Amendments

Cliff Cottage-Helen Webster1.pdf

Please find attached a rough alteration to the original drawings for Cliff Cottage. Only the front and side elevations have so for been altered.

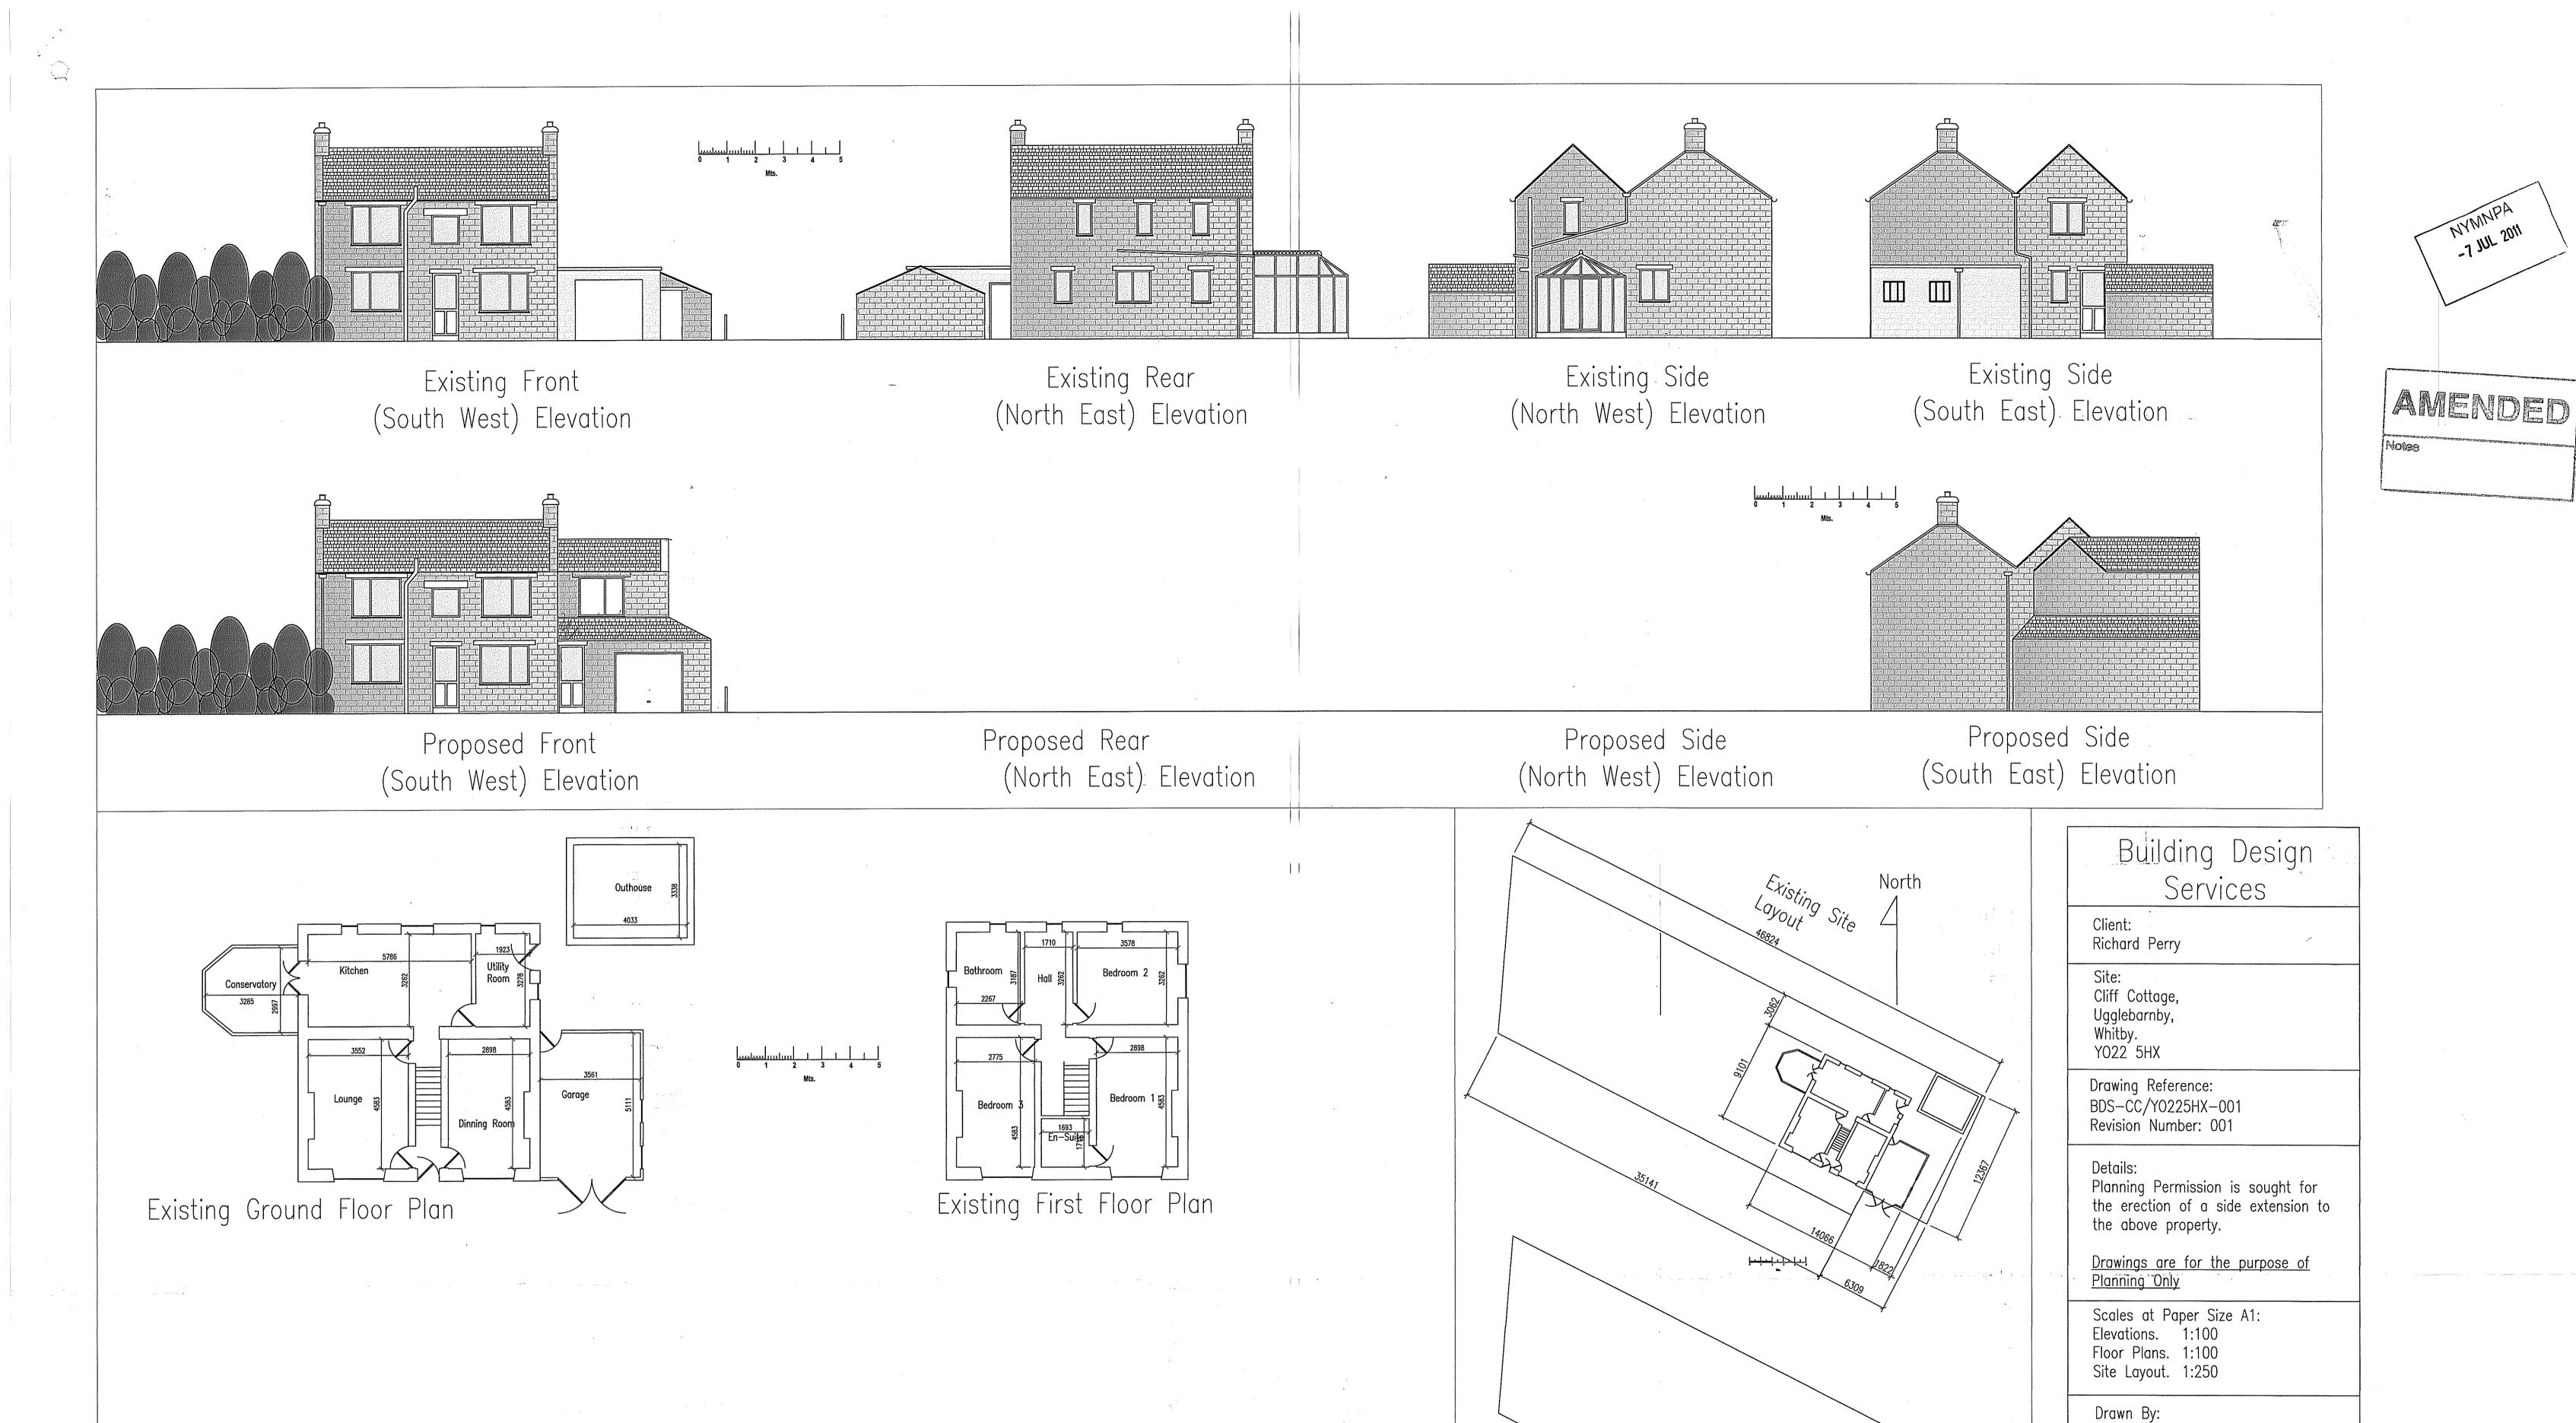
You should be able to get a feel of the size of the development from these. Hope this is satisfactory with you. Your comments would be appreciated.
